Technical Service Bulletin

Subject: WHITE LINES APPEAR IN INSTRUMENT CLUSTER	Bulletin No.: 09-018/20
	Last Issued: 10/30/2020

Mazda3 (Mexico built) vehicles:

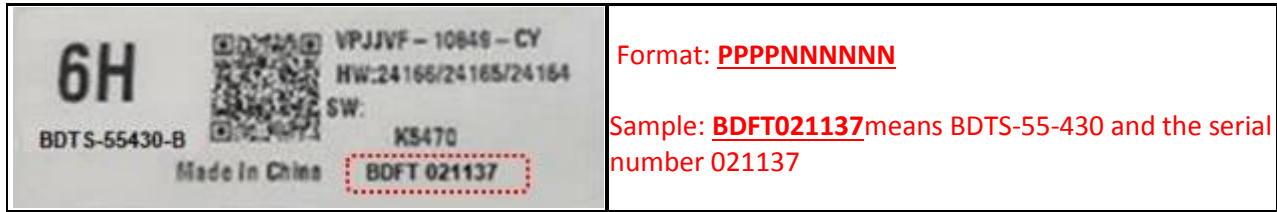
The lot number on the label consists of 4 digits for the part number (PPPP) and 6 digits (NNNNNN) for the serial number (it does not include the production date).

<p>Format: <u>PPPPNNNNNN</u></p> <p>Sample: BDFT021137 means BDTS-55-430 and the serial number 021137</p>
--	---

NOTE: If the serial number on the label is the same or later than the First Modified Lot Number (as shown above), it is a modified part.

Part Number	First Modified Lot Number
BEDP-55-430B	BEGT 035077
BFRW-55-430A	BFKL 032895
BDTS-55-430B	BDFT 021137
BDCJ-55-430A	BDJL 037762
